Access Compliance Report

Public Rights-of-Way

(Curb Ramps)

Intersection ID: 5716	Main Street: SPANISH_MOSS_LN	Cross Street: WILD_ORCHID_CT	Location: E
ADA ID: AC72906C1754	Ramp Type: Perp	Initial Pass/Fail: Fail	Overall Compliance: No
			Severity Score: 8.75

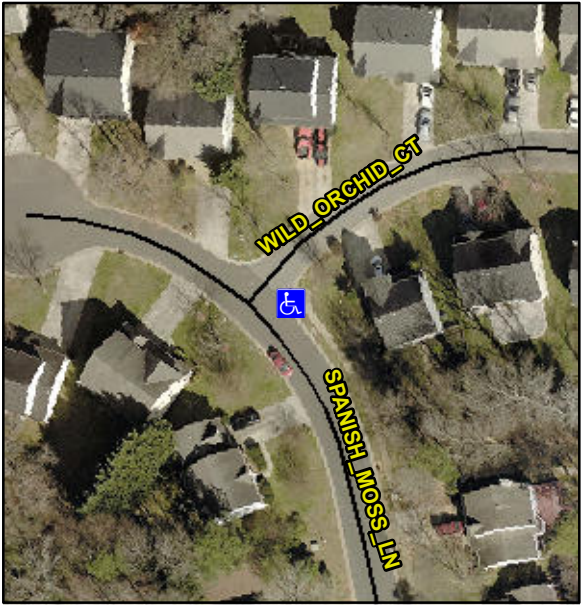
Codes/Mitigation Info/Possible Solution			Field Measurements/Component Compliance																																																																																																																																																														
 <p>Possible Solutions:</p> <p>Remove & Replace Entire Ramp.</p> <p>Surveyor Notes:</p> <p>N/A</p> <p>PROW/ADA:</p> <p>Not Found, R304.5.1</p>

<table><tr> <th>Compliance</th><th>Description</th><th>Data</th><th>Compliance</th><th>Description</th><th>Data</th></tr><tr> <td>No</td><td>Ramp Width (in)</td><td>36.0</td><td>Yes</td><td>Ramp XSlope (%)</td><td>0.7</td></tr></table>
